Economic and Social Council

Working Party on Lighting and Light-Signalling

Sixty-eighth session

Report of the Working Party on Lighting and Light-Signalling on its sixty-eighth session

D. Proposal for Supplement 22 to the 02 series of amendments to Regulation No.7

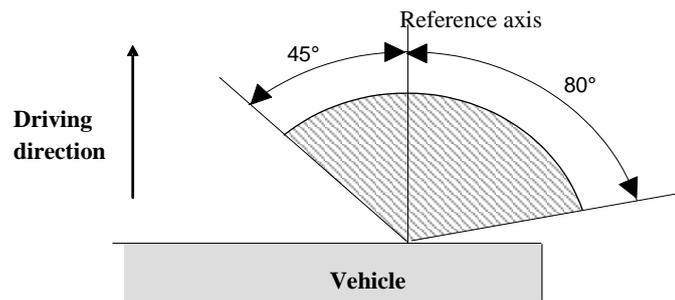
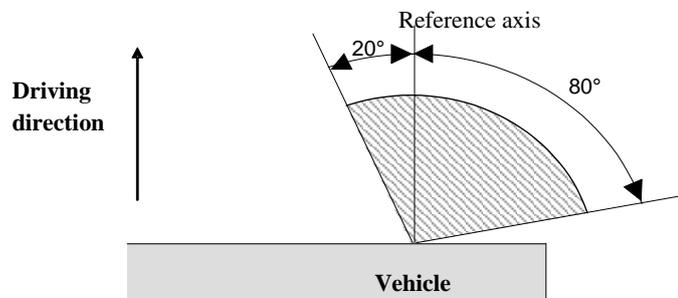
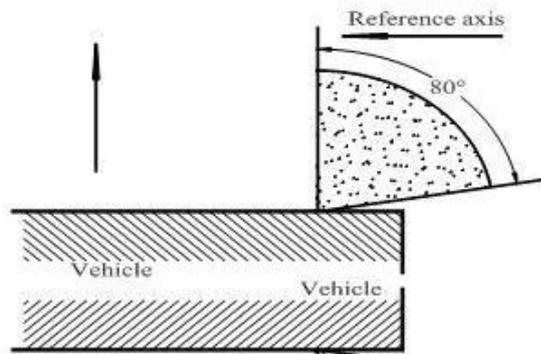
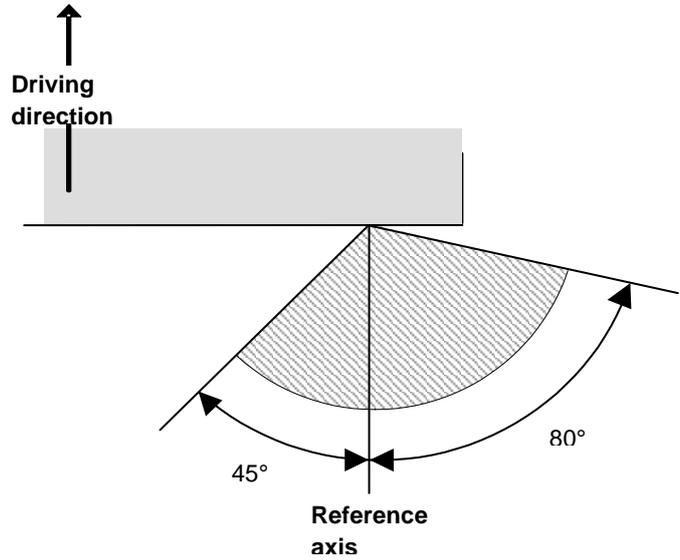
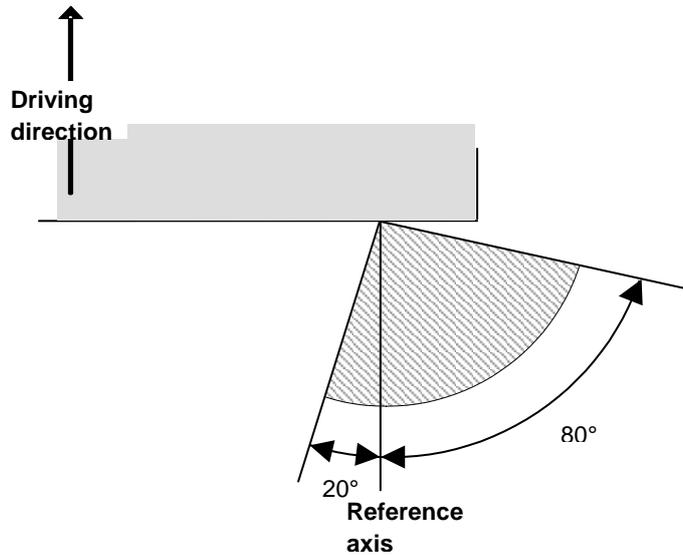
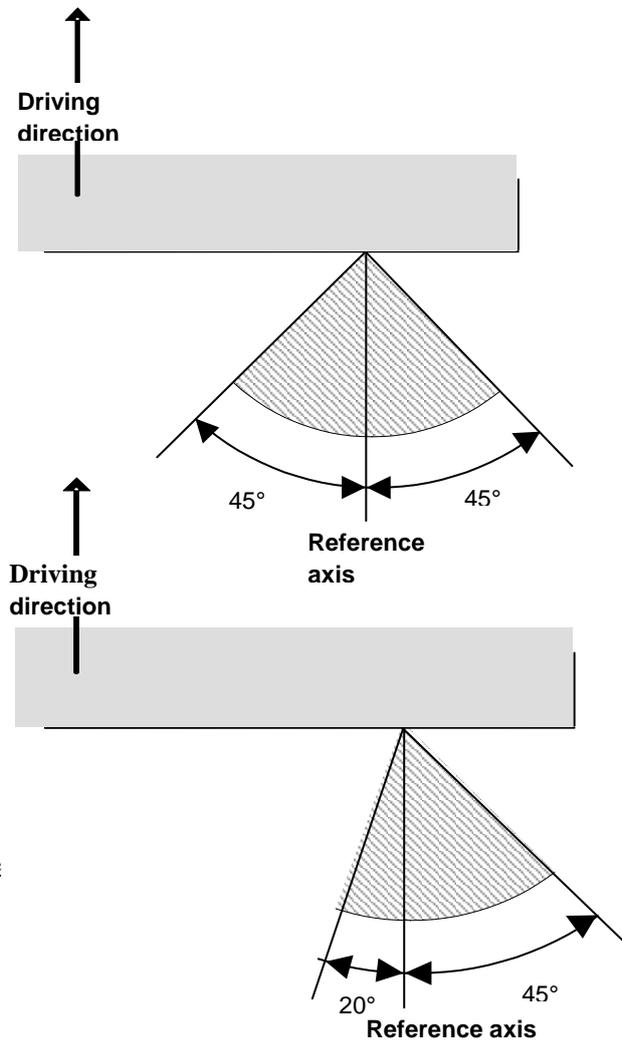
Annex 1, amend to read:

Under the H plane for front position lamps intended to be installed with this plane at a mounting height less than 750mm above ground.

Under the H plane for rear position lamps intended to be installed with this plane at a mounting height less than 750mm above ground.

Under the H plane for stop lamps (S1 and S2) intended to be installed with this plane at a mounting height less than 750mm above ground.
